PRPF20241230
 CASCADE CHRISTIAN SCHOOLS
 ELEMENTARY SCHOOL
 PORTABLE PLACEMENTS
 811 21ST STREET SE
 PUYALLUP, WA 98372

PROJECT:	28x64 CLASSROOM			DRAWING TITLE:	FOUNDATION / CRAWLSPACE PLAN		
CLIENT:	ATCO STRUCTURES AND LOGISTICS			PROJECT NO:	1106442-A	DRAWING NO:	SC100
				REV. #			1

Project: **Cascade Christian Schools Classroom/Washcar/ATCO stock classrooms at Puyallup, WA**

Subject: Certified Letter for X-Plate Anchor

3 FOUNDATION SOIL ANCHOR

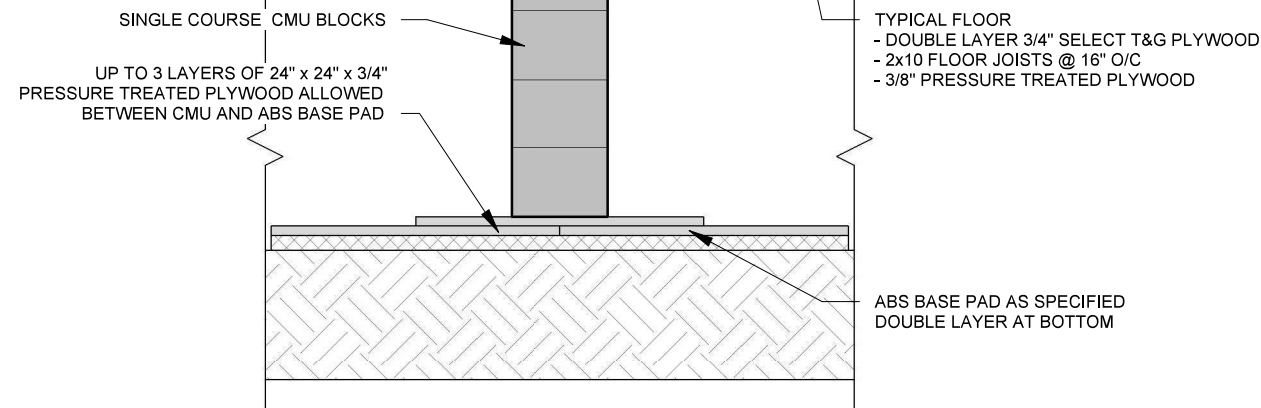
The purpose of this letter is to certify that the modular tie-down earth auger anchor may be substitute with X-Plate anchor for difficult class 2 soil condition. The number of anchors, however, shall be increased by 43% at each tie-down direction. (Lateral capacity of Earth auger is 3150 lb. Thus $3150 \text{ lb} / 2200 \text{ lb} = 143\%$). For Example: If the original number of earth auger tie-down is 9 per the long side of building, and 4 per the gable end side of the building. Therefore, using the X-Plate anchors, the revised quantity shall be 13 per the long side of the building, and 6 per the gable end side of the building. The anchor shall be placed at approximately equally spaced, plus minus 12".

X-Plate Anchor
Stabilized Cross Drive
Anchor For difficult
class 2 Soils. 2200 lb.
working load at 50 degrees
max angle.
